Product Change Notice #: VI20210202 Date: February 4, 2021

This is to inform you of specification change to Vicor NBM2317S60E1560T0R.

Package Outline Drawing Improvement

BOTTOM VIEW

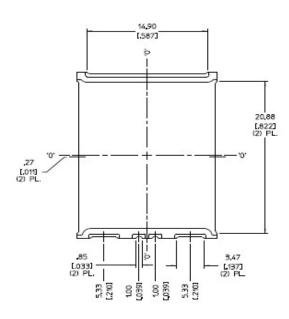
This notice is to make you aware of a change to the NBM2317S60E1560T0R package outline drawing.

New Package Dimensions

Present Package Dimensions

This change is to improve panel level handling in the Vicor factory.

Customers should note that this change will have **no** impact on form, fit, function including product electrical performance and soldering guidelines.
